Value Engineering Study

Final Report

VE Number: 202303

I-75 Widening, MP 20.2 to MP 28.851 Laurel & Whitley Counties

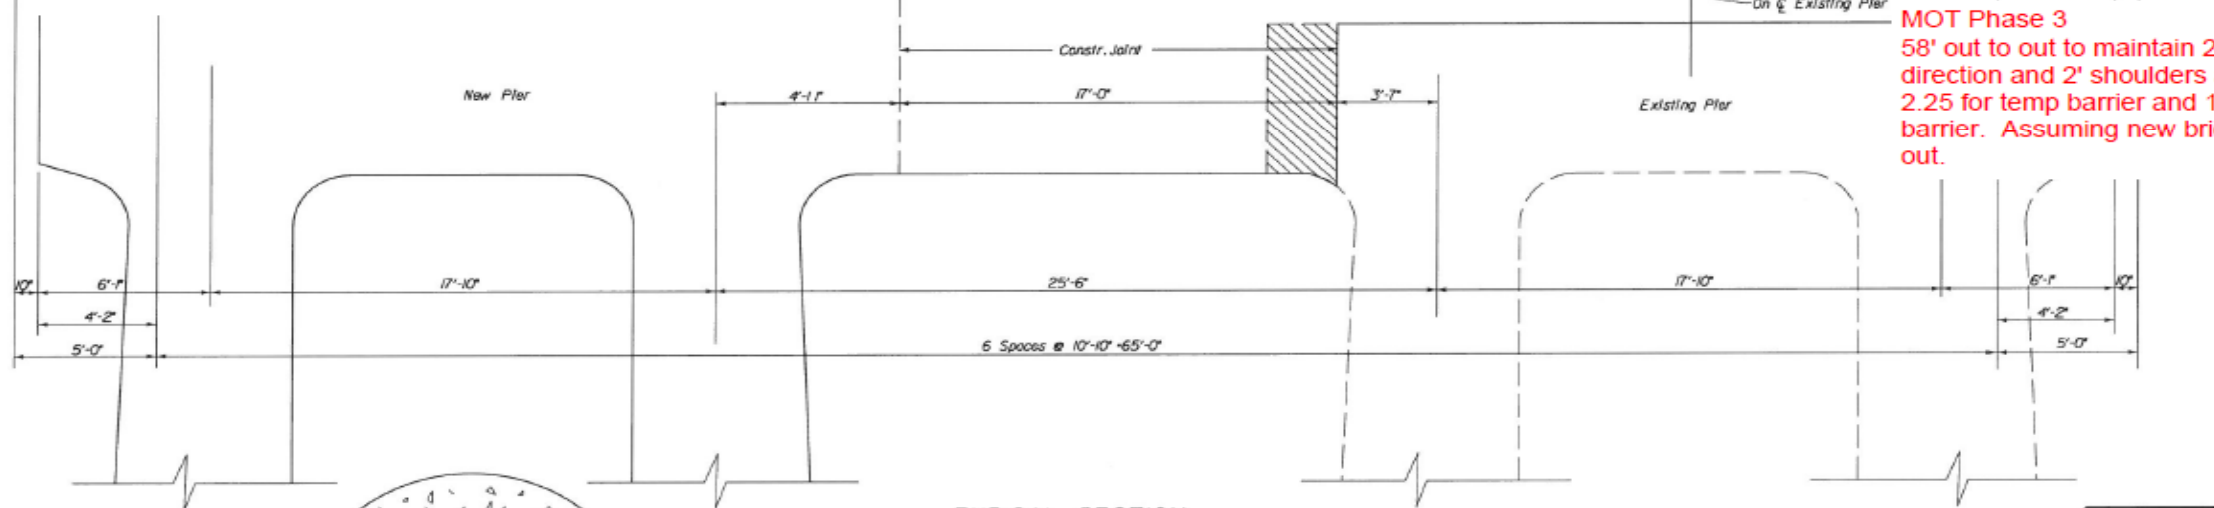
TITLE	Widen one structure on Lynn Camp Creek Bridge to provide 4 lanes of traffic (2 in each direction) in order to minimize construction phasing on the second structure
--------------	---

TITLE	Widen one structure on Lynn Camp Creek Bridge to provide 4 lanes of traffic (2 in each direction) in order to minimize construction phasing on the second structure
DISCUSSION & JUSTIFICATION:	
<p>Construction of the piers for the widening will take a considerable amount of time each. With the contractor forming and pouring about 20' at a time, we are estimating approximately 6 months each side for the substructure. By building one direction in 2 phases, we allow for complete demolition of the other bridge. The limiting factor for a vertical pour is the height. The contractor would be able to form and pour all the substructure for each lift as opposed to splitting it up. This could in turn lead to a different pier design on the second structure since the existing bridge will be completely removed first.</p> <p>By building the structure as one unit instead of phasing, you can eliminate the longitudinal construction joint in the pier, the longitudinal construction joint in the deck, the phased placement of armored edges and joint material. All this can be done while not impacting the traveling public at all. 2 lanes can be maintained on the new structure built in phase 1 and 2.</p> <p>The contractor will be able to stage material for the second bridge in the closed portion of interstate, receive beams safer, minimize any crane pads needed below (would only need one pad per pier instead of two). There is little doubt that the Lynn Camp Creek bridge will be the critical path for the project. By eliminating the 2 phase from the second bridge we immediately save 6 months off the construction.</p> <p>While crossovers do cost money, the logical locations for cross overs can exist in the areas just north and south of the bifurcated areas, allowing the majority of temporary pavement needed to actually line up with permanent pavement.</p> <p>The cost to construct these cross overs is minimal when compared with time savings and joint elimination which is one of the main locations where we see bridges begin to deteriorate.</p> <p>The cost estimate reflects a price change in concrete class A and concrete class AA. While the typical section of the bridge doesn't change, by reducing the phasing the contractor no longer needs the pump truck for those two phases. They also no longer need the bidwell and deck pour crew for two phases, just one. The production rate of the crew can increase because the contractor can form twice as much as they normally would during phased construction (due to vertical limitations).</p> <p>The median cross over is assuming leveling and wedge at 3" average depths to obtain super elevations. Assuming a 50 median width, and a length of 2000' at 26' width, that equates to \$88,000 per crossover.</p>

Assuming 12' disappears because it will be 3 lanes in the ultimate not 4 as in this plan

MOT Phase 3
58' out to out to maintain 2 lanes in each direction and 2' shoulders across the bridge, 2.25 for temp barrier and 1.5' for perm outside barrier. Assuming new bridge will be 63' out to out.

31

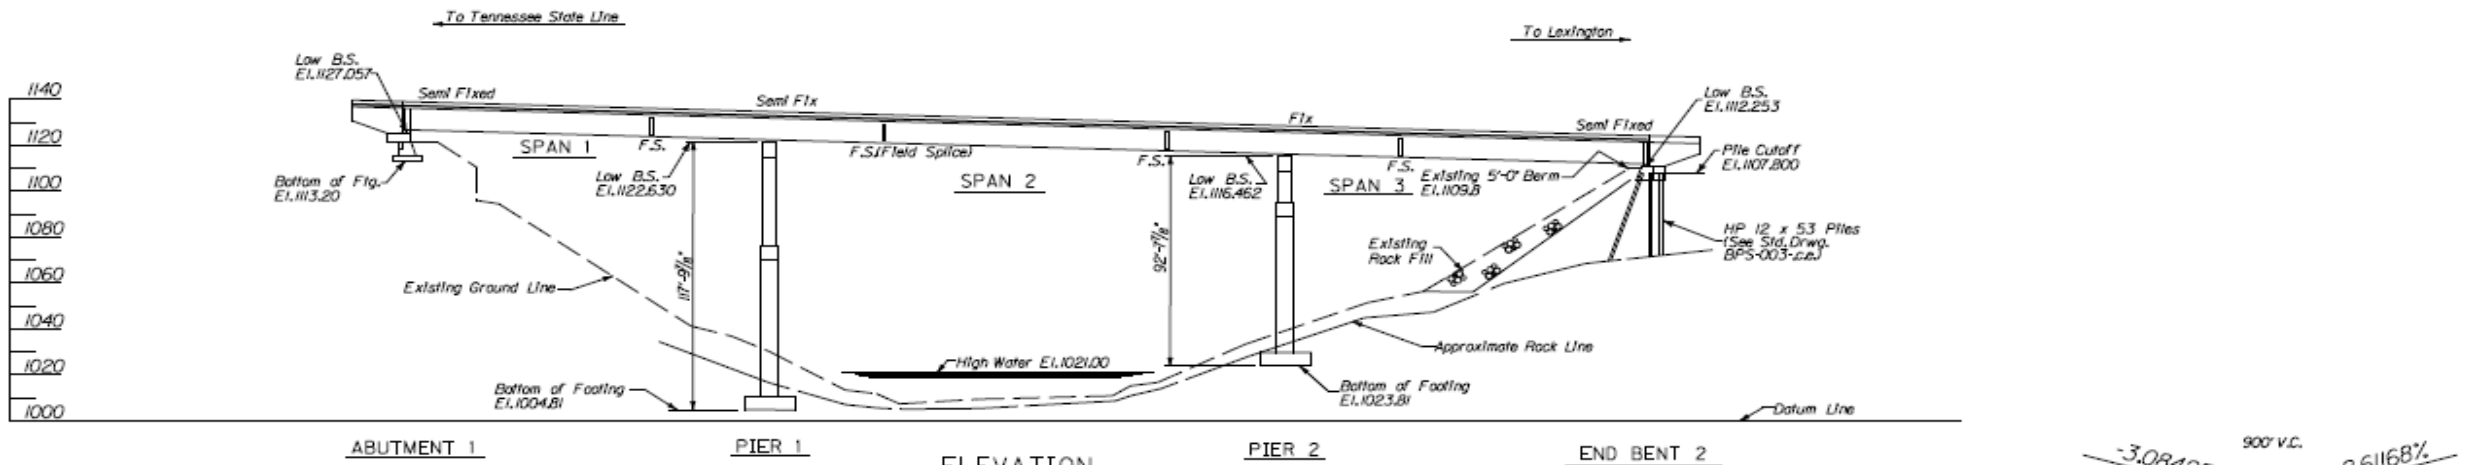
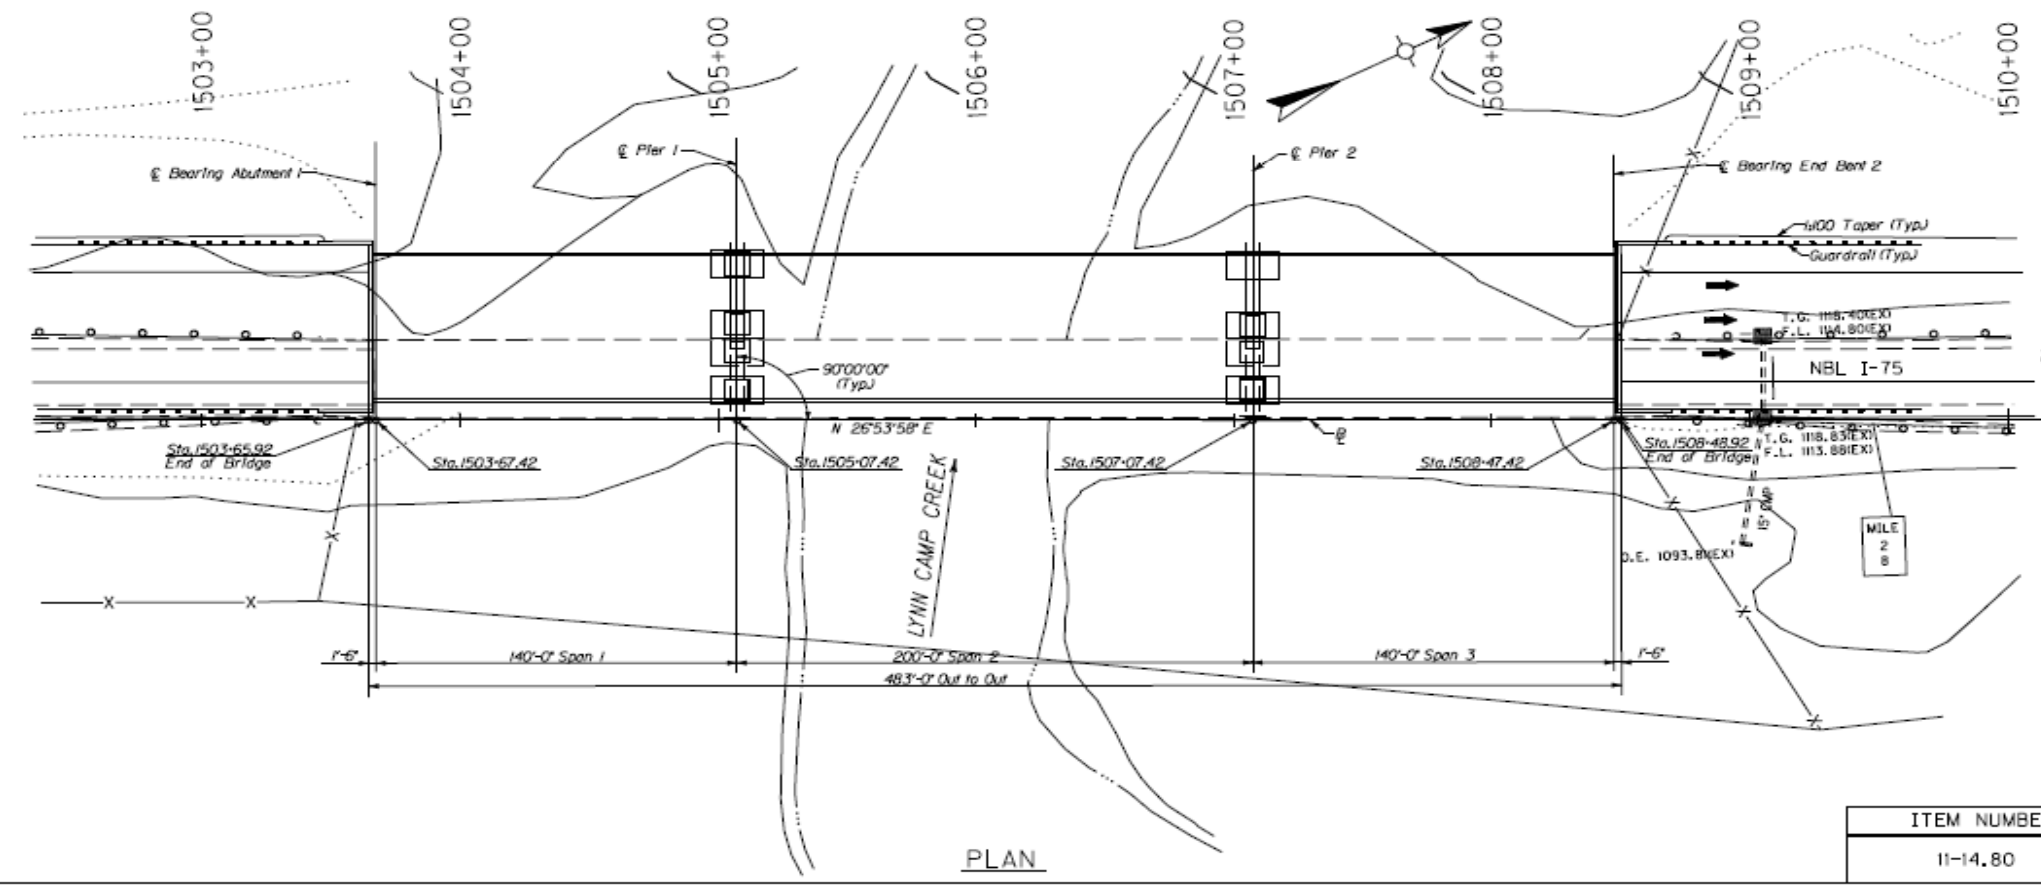
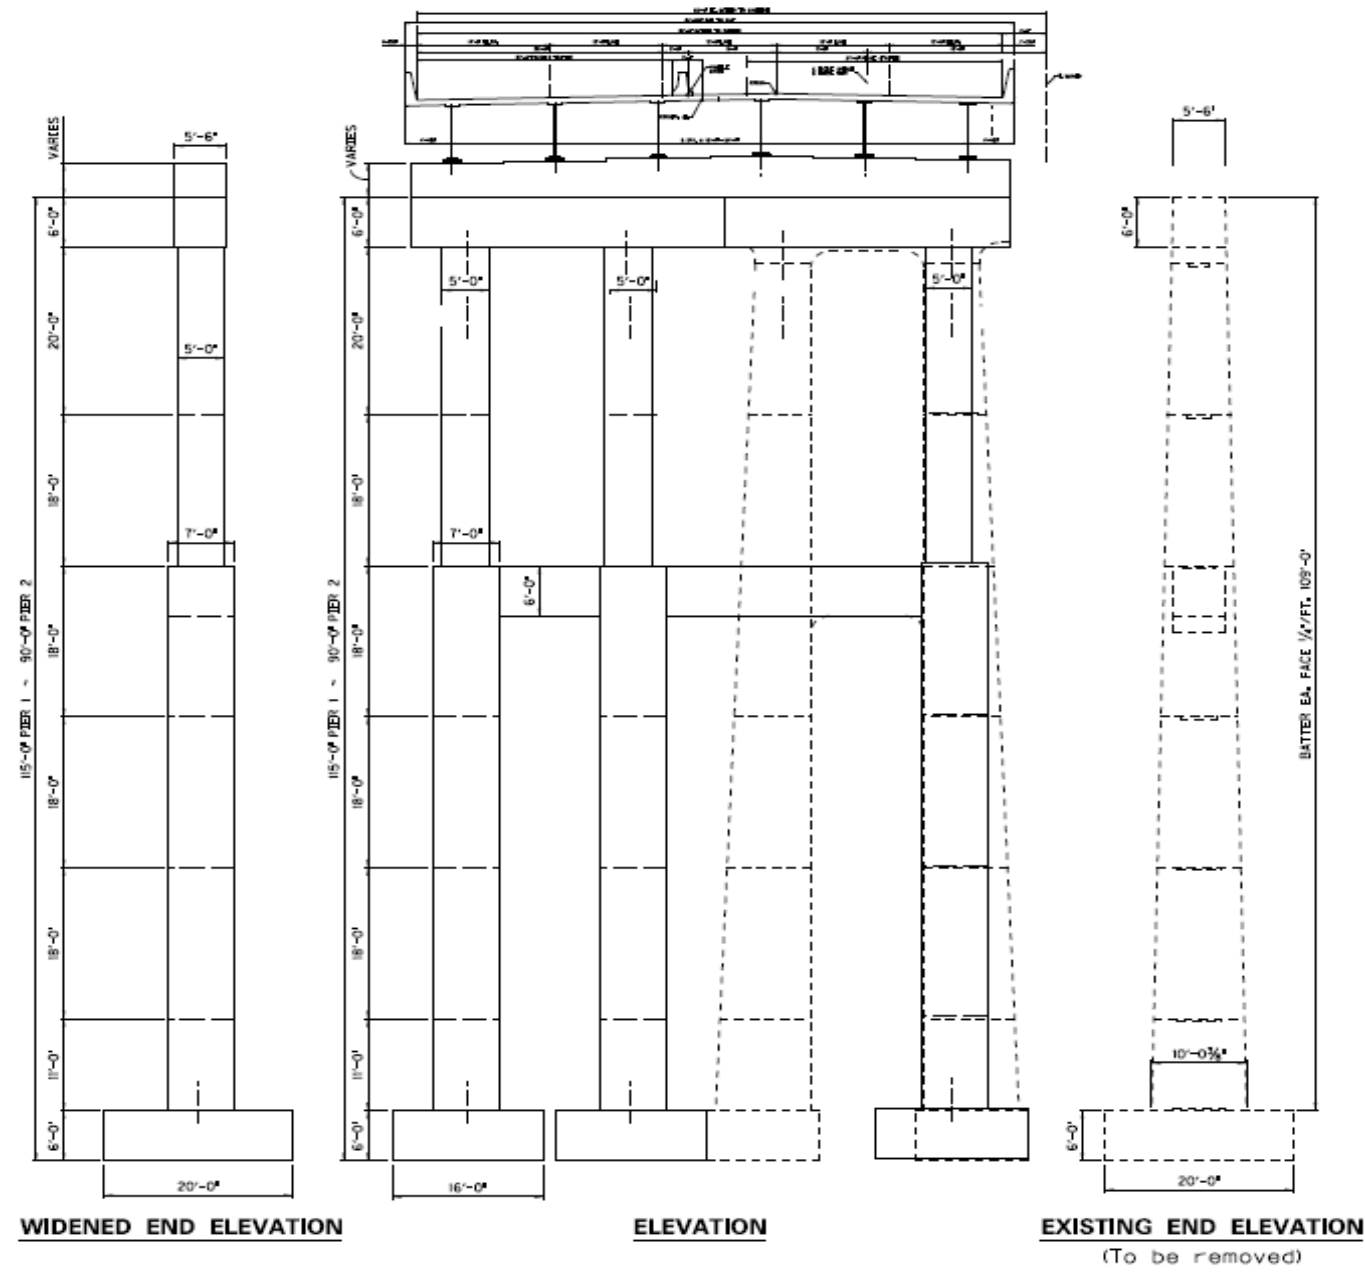
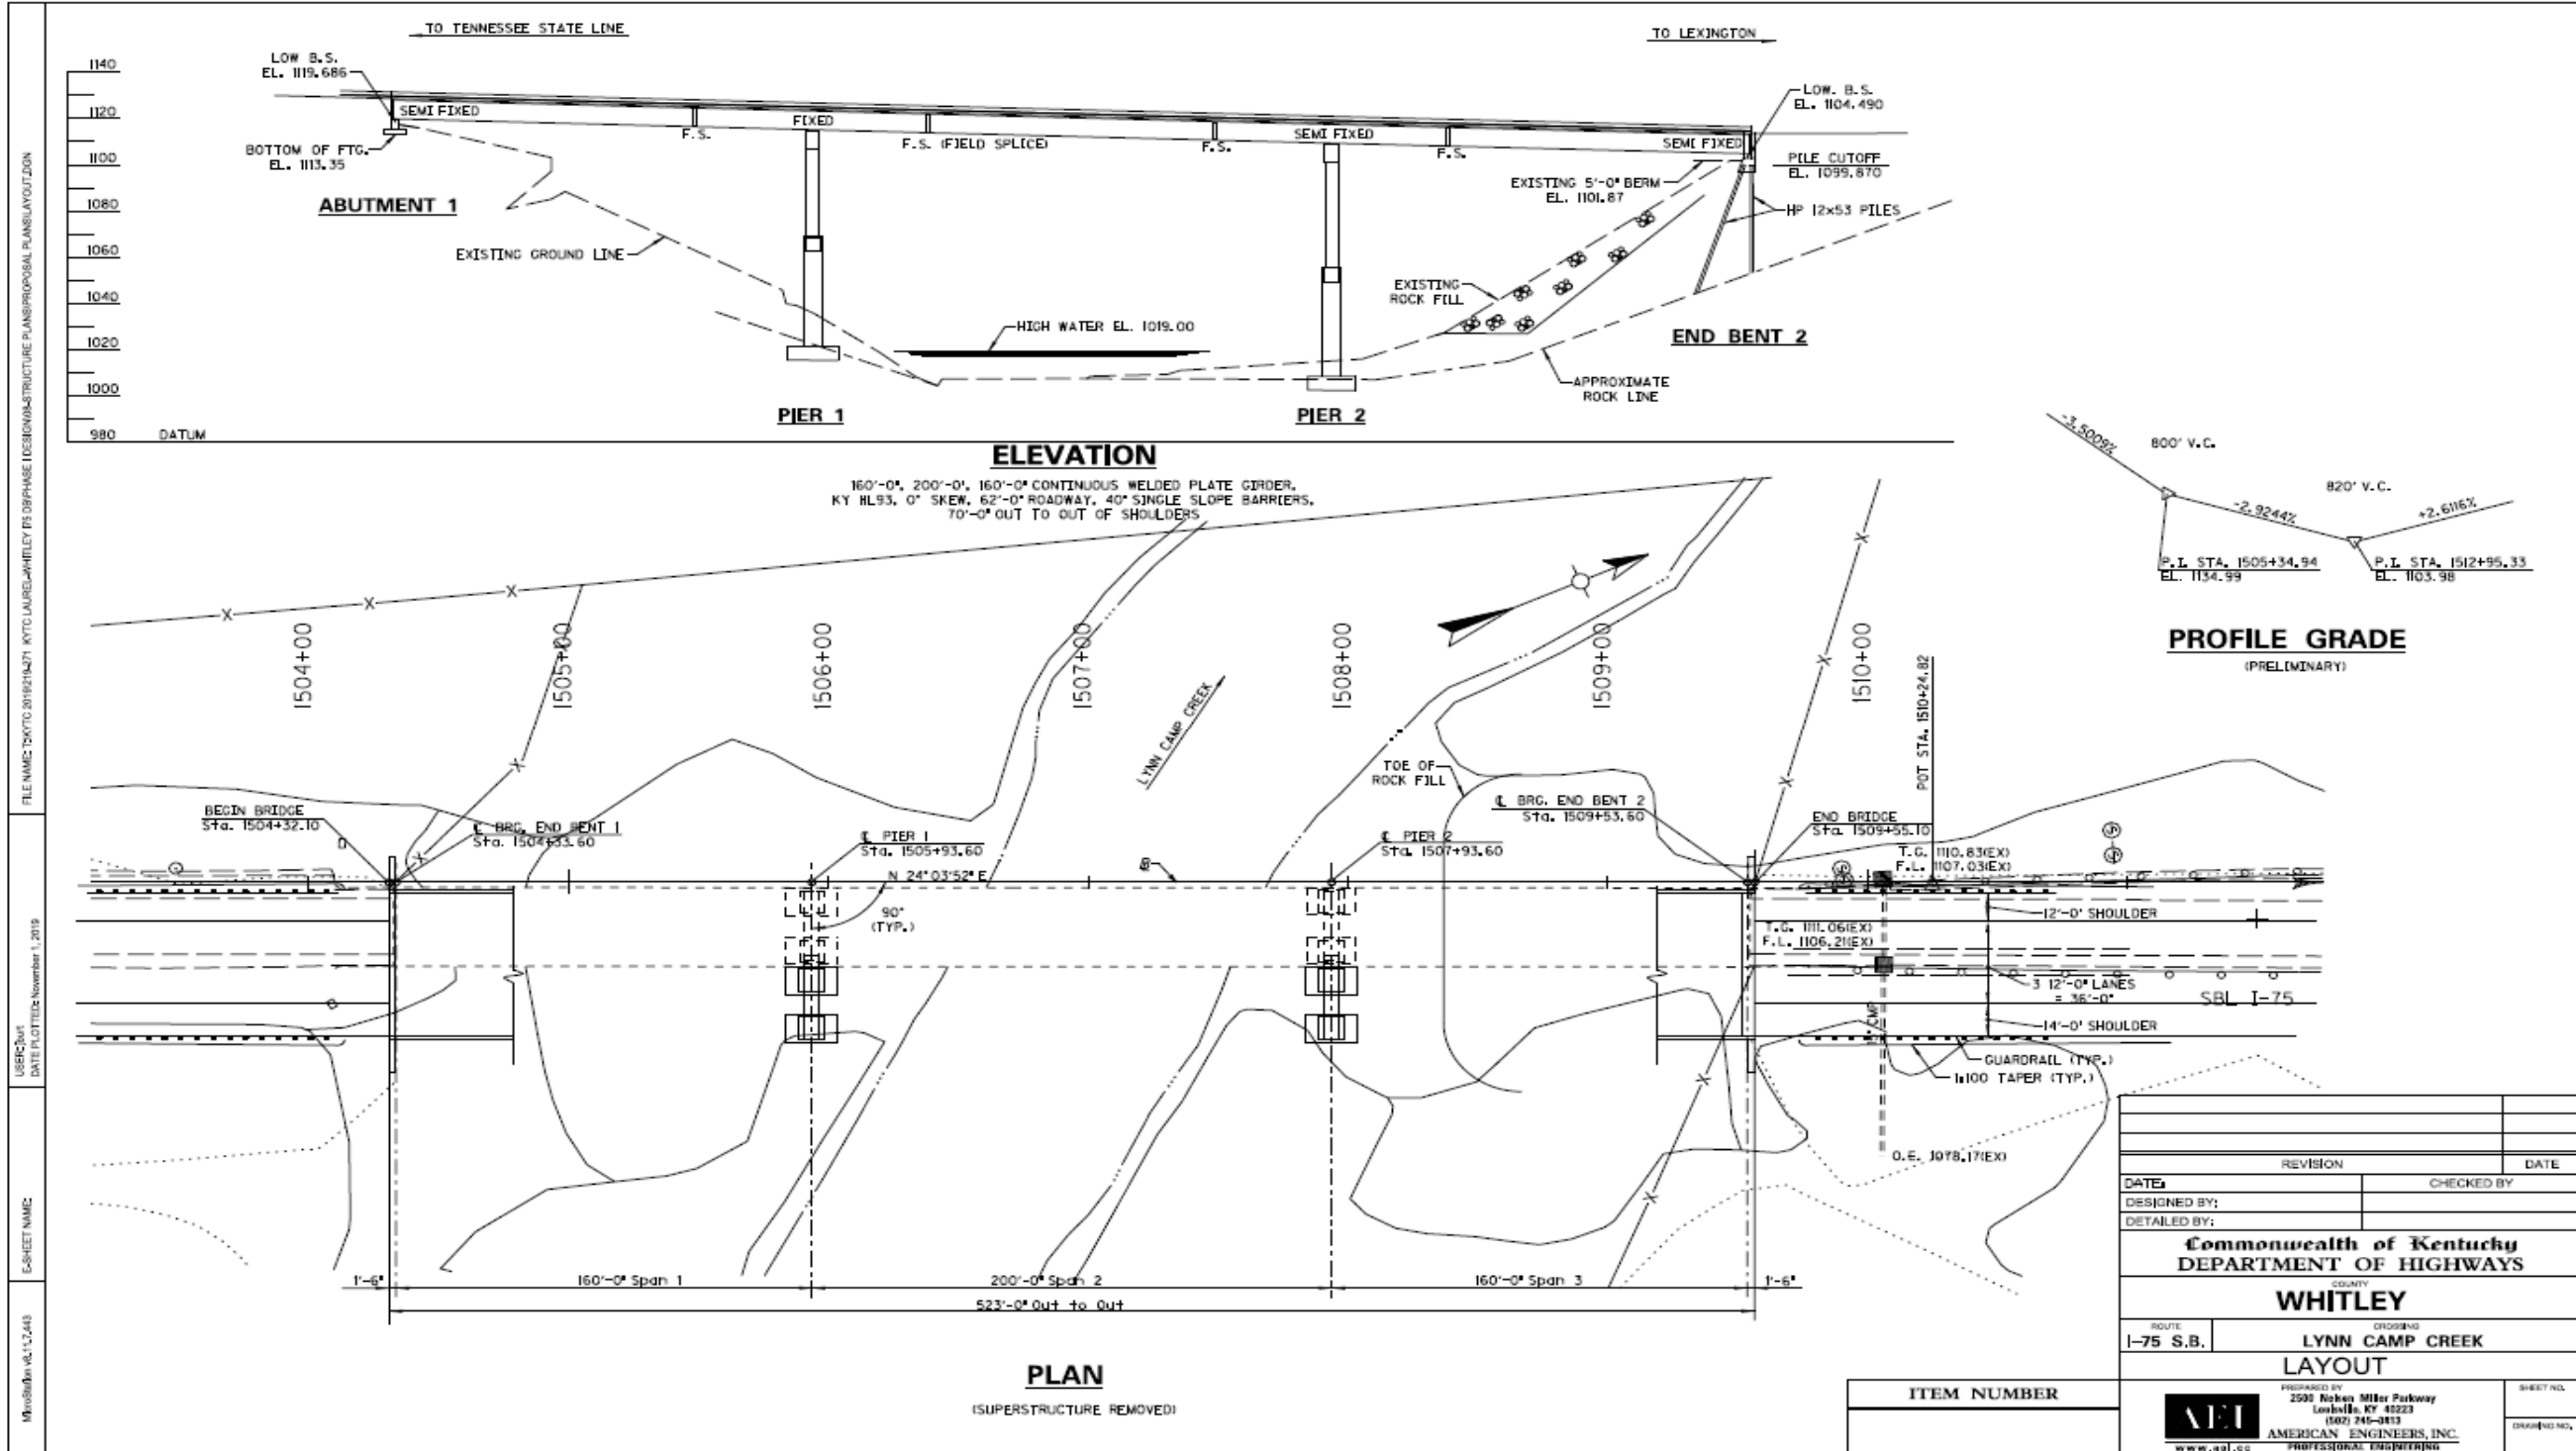
TITLE	Reuse substructures for Lynn Camp Bridge		
VALUE PROPOSAL SYNOPSIS:			
Reuse existing substructure at the Lynn Camp Creek bridge. Cost savings and time savings can be realized by using the existing substructures.			
 Reliability	Maintained	 Functionality	Maintained
 O&M	Maintained	 Schedule Impact	Improved
			\$ Initial Cost Avoidance (Add)
			\$3,392,000
BASELINE CONCEPT:			
The existing structures would be replaced with completely new structures.			
VALUE PROPOSAL DESCRIPTION:			
Widen and reuse existing substructure at Lynn Camp Creek to reduce schedule and reduce cost.			
ADVANTAGES:		DISADVANTAGES:	
● Cost savings		● Not a new structure	
● Easier constructability		● May need to repair (epoxy inject)	
● Shorter construction		● May need to strengthen	
●		●	
●		●	
●		●	
●		●	
\$ COST SUMMARY		Initial Costs	O&M Costs
		Total Life Cycle Cost	
BASELINE CONCEPT:		\$19,526,000	\$0
VALUE PROPOSAL DESCRIPTION:		\$16,134,000	\$0
